ADDENDUM NO. 2

PROJECT: **Frog Eye Road Bridge Replacement**
County Contract No. BR-FE-225-14

FROG EYE ROAD
BRIDGE REPLACEMENT

COUNTY CONTRACT NO. BR-FE-225-14

SHEET NO.
7R

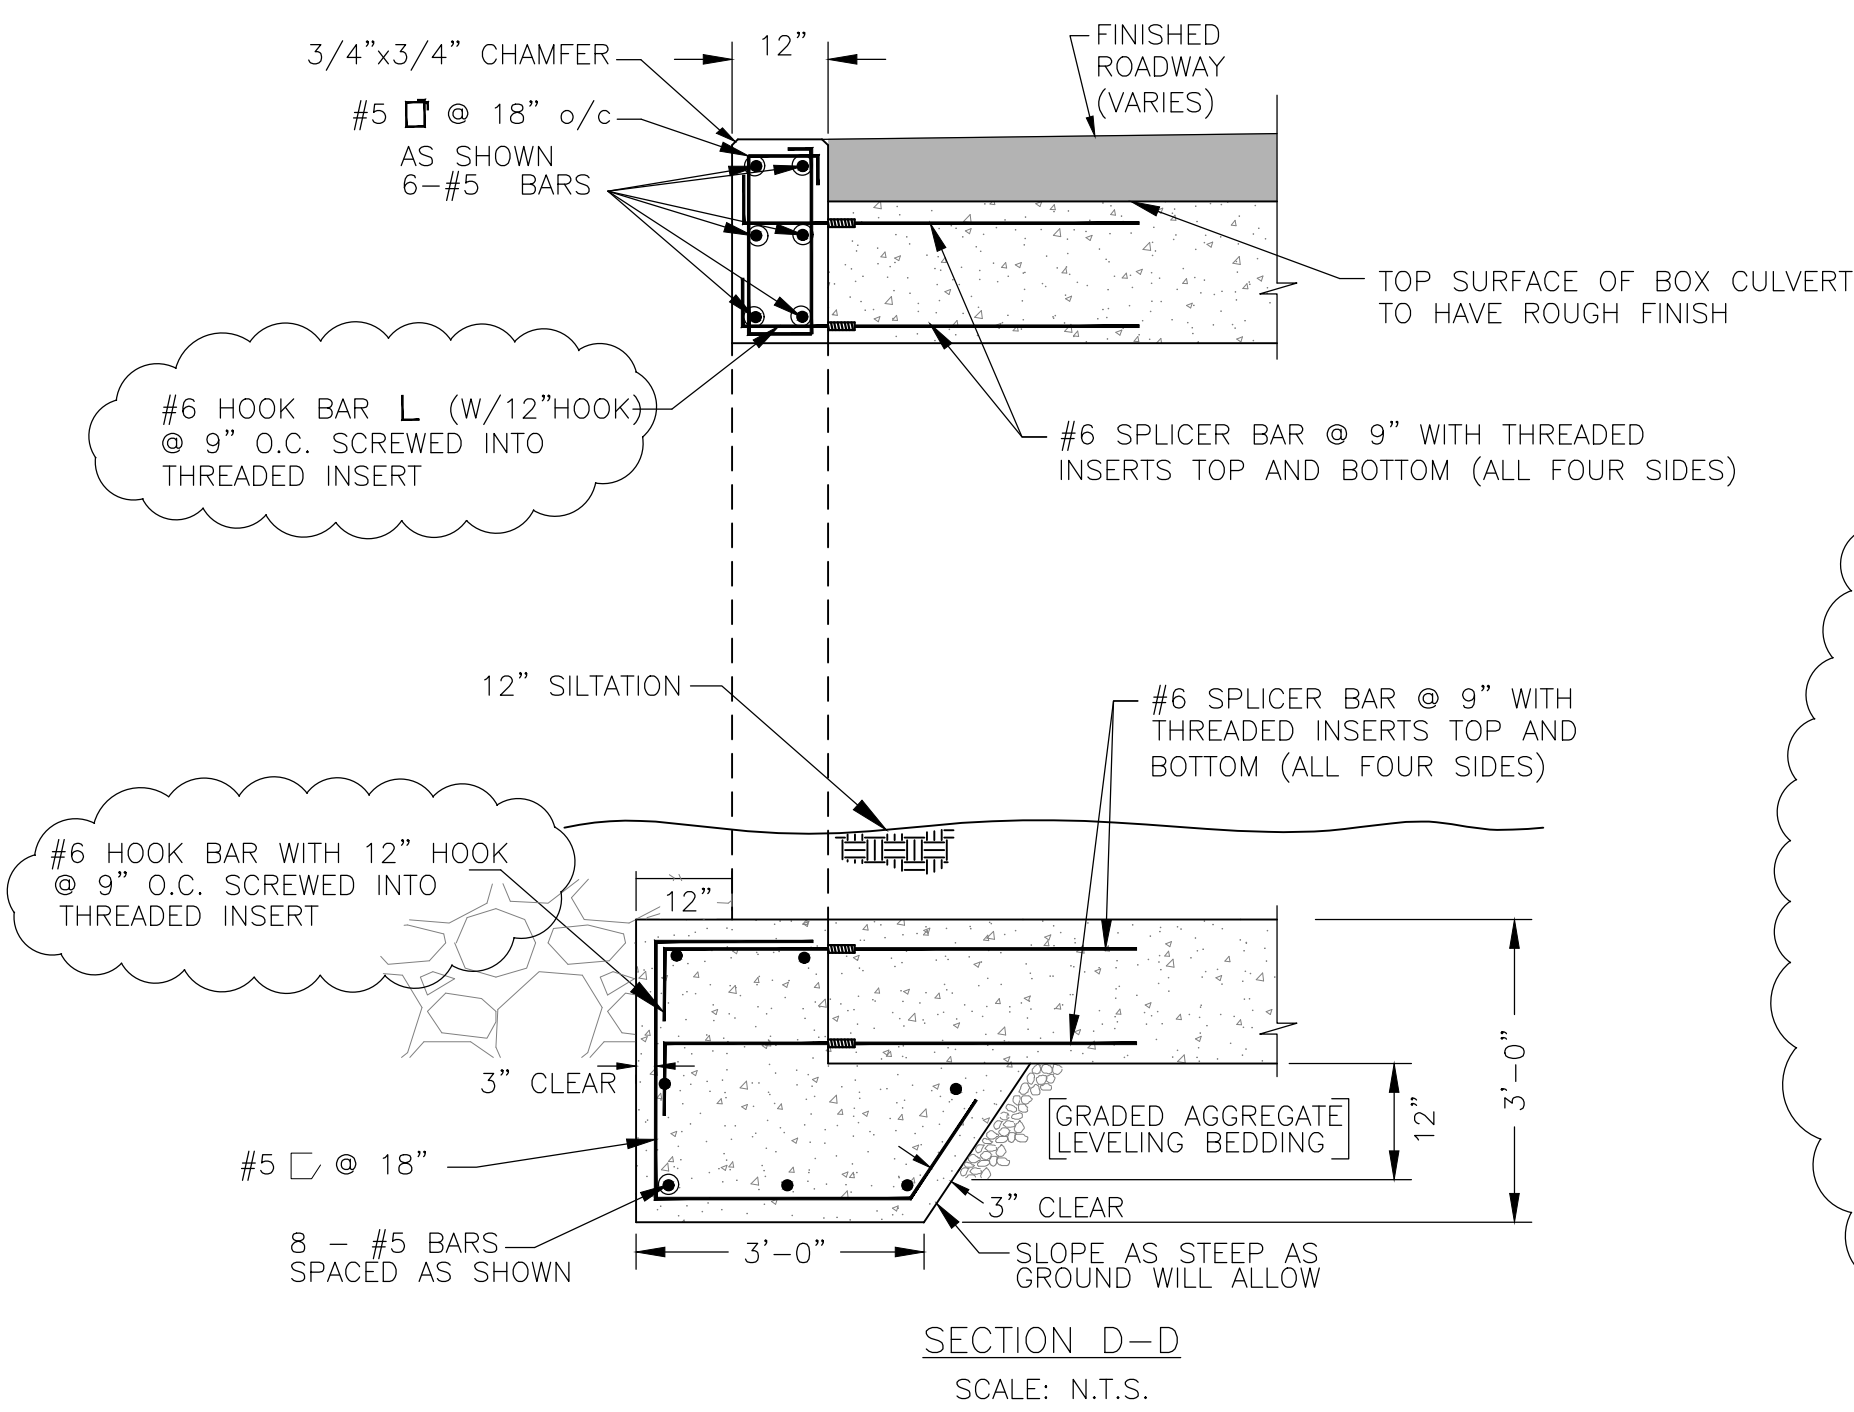
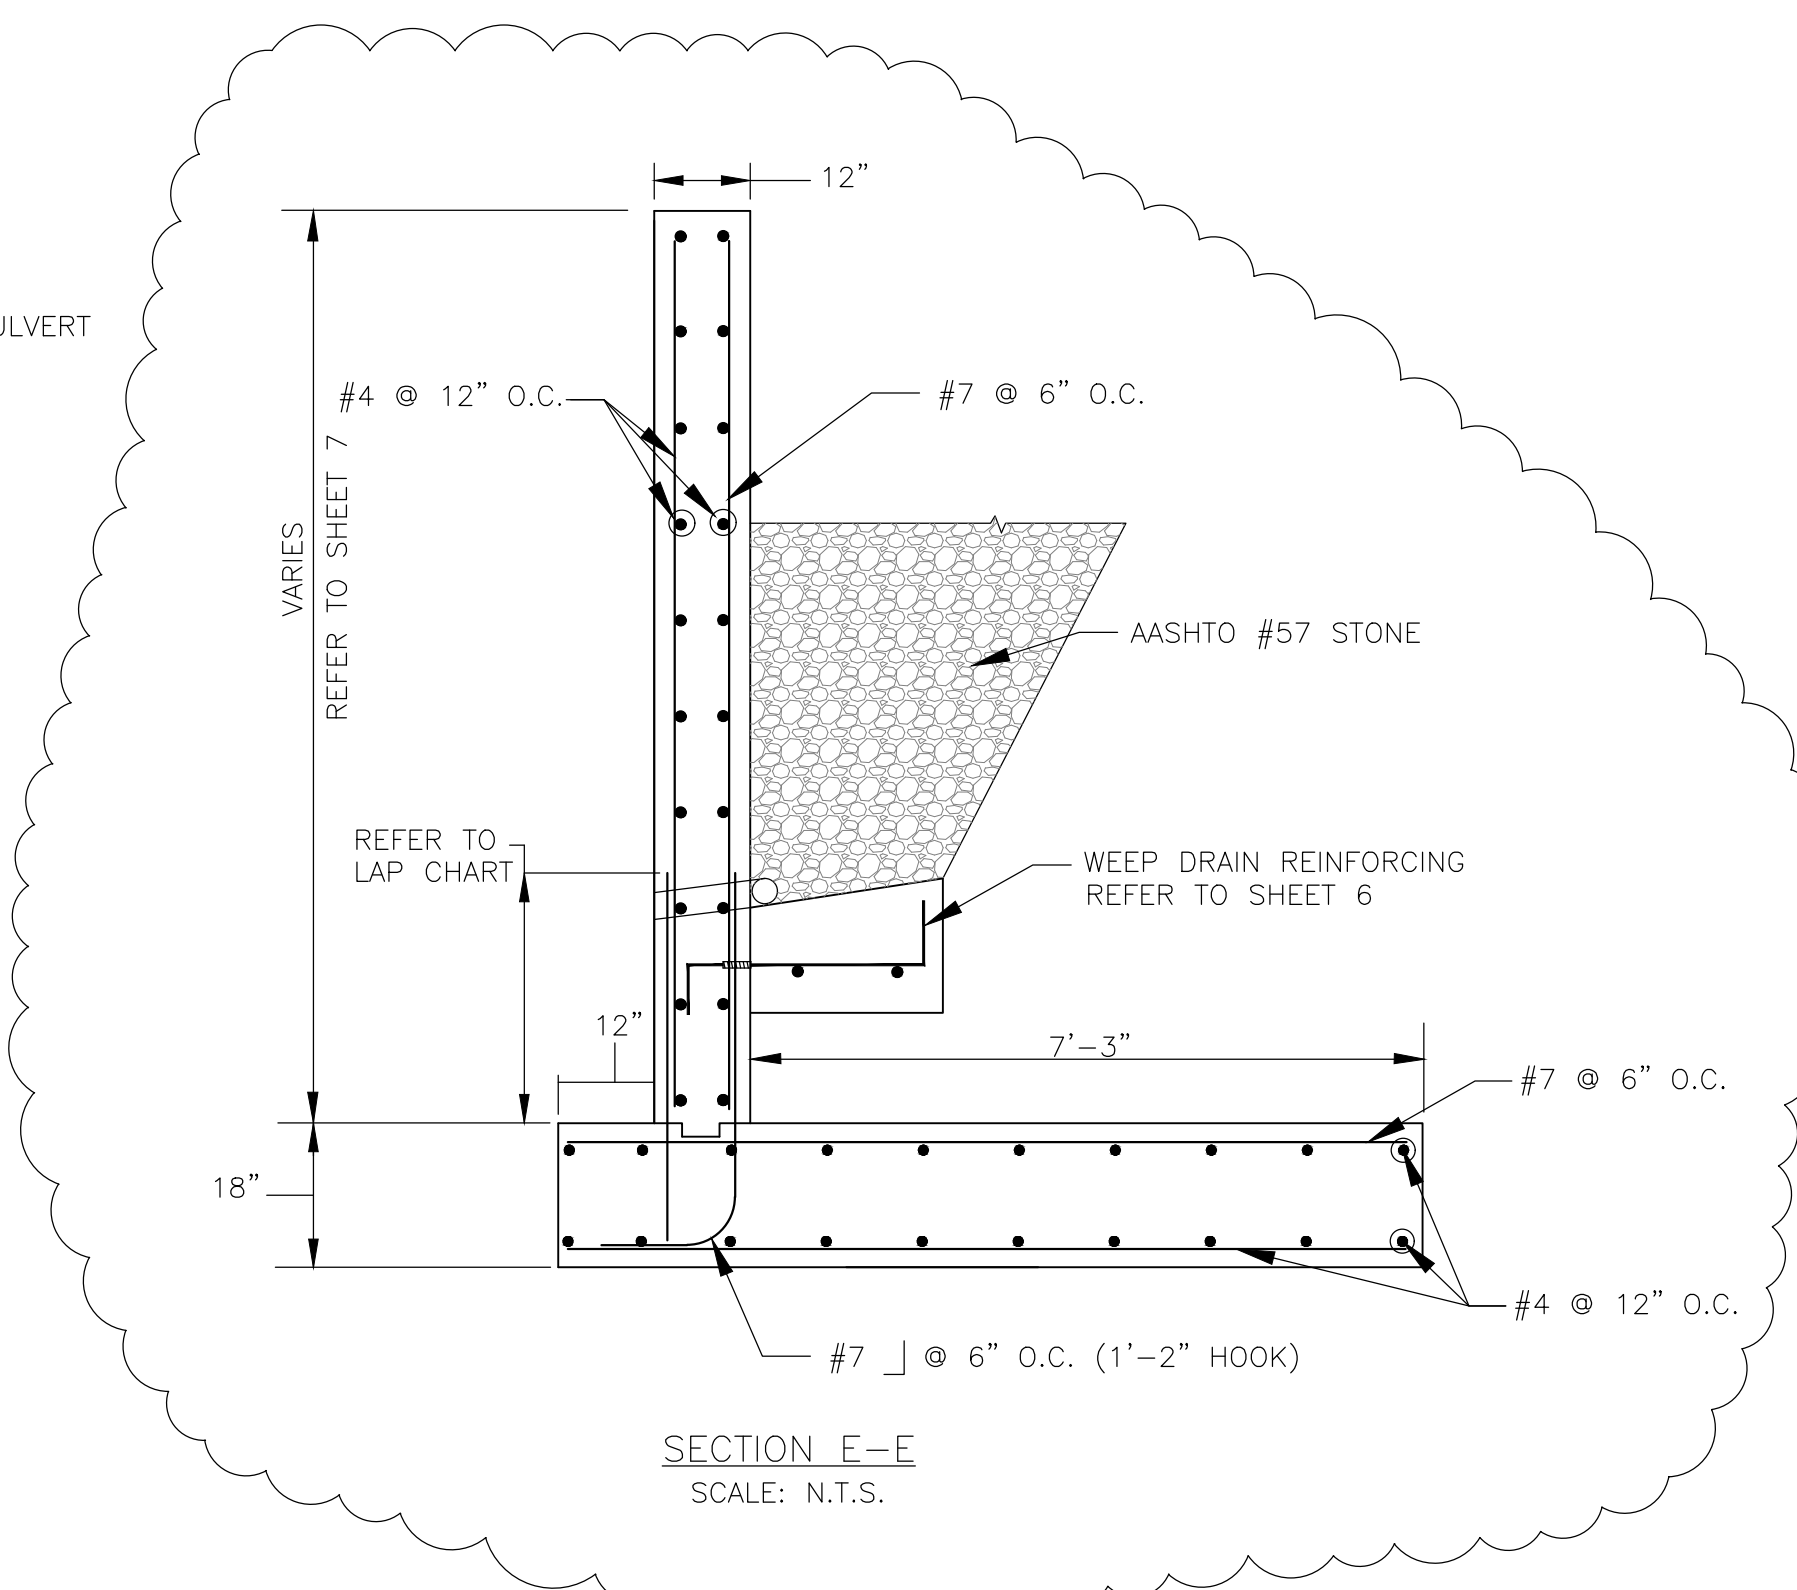
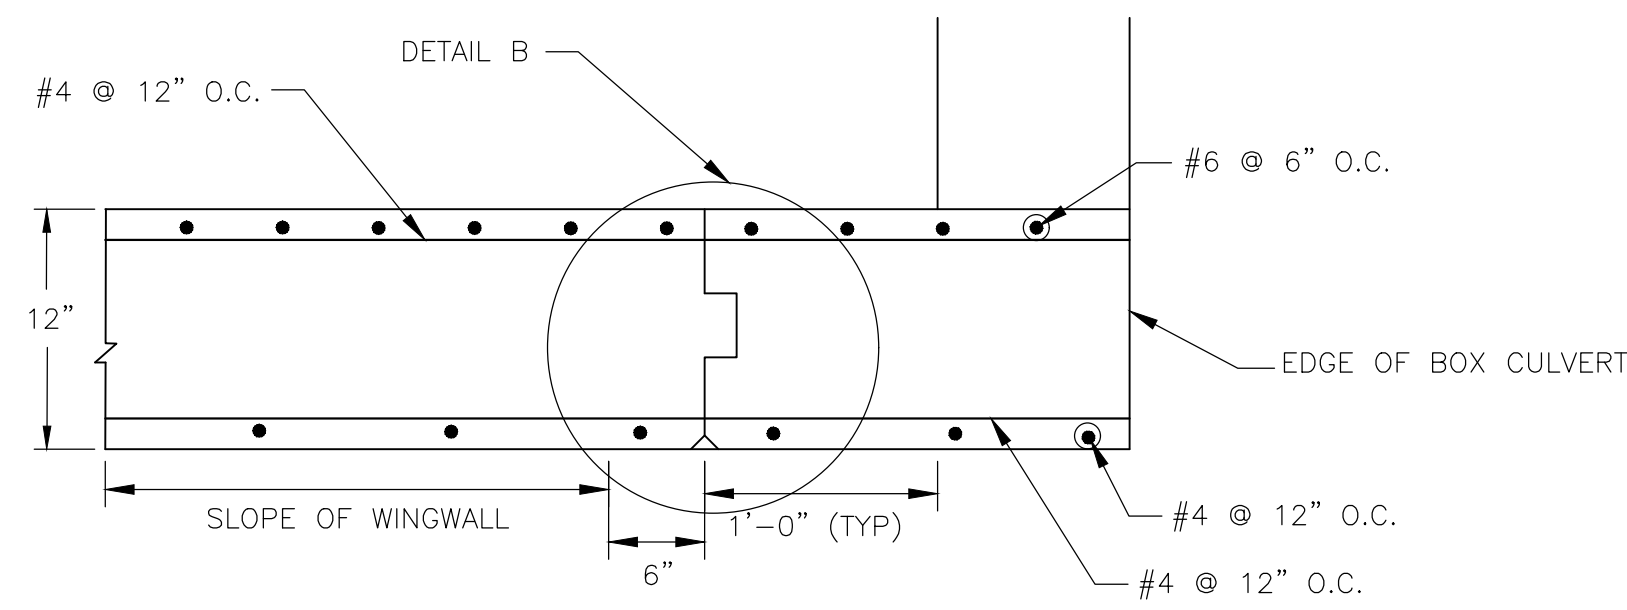
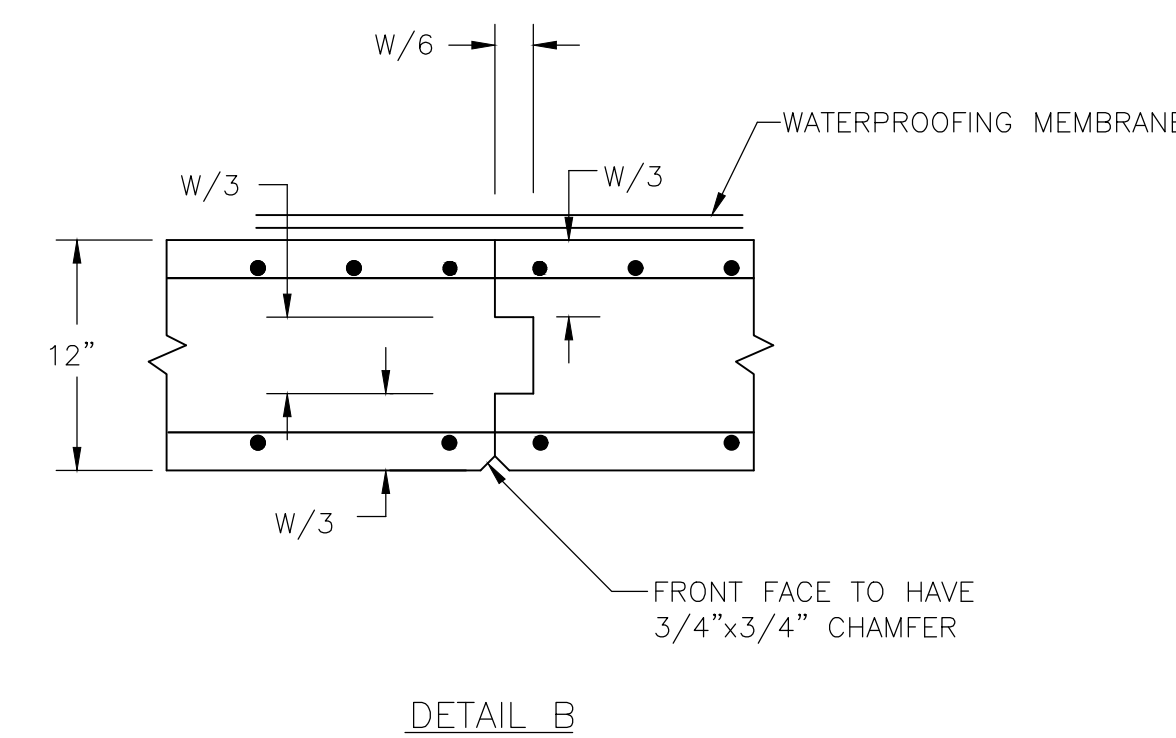
REPLACE Special Provision Item 403 – Reinforced Concrete Mix No. 3 for Endwalls with REVISED Special Provision Item 403R – Reinforced Concrete Mix No. 3 for Endwall Footings and ADDED Special Provision Item 405R - Reinforced Concrete Mix No. 6 for Endwall Stems. *(Revisions are shown in bold print.)*

CAST-IN-PLACE CONCRETE: CONCRETE FOR HEADWALL AND WINGWALL STEMS SHALL BE MSHA MIX NO. 6 (4,500 PSI MIN.). FOOTINGS SHALL BE MSHA MIX NO. 3 (3,500 PSI MIN.).
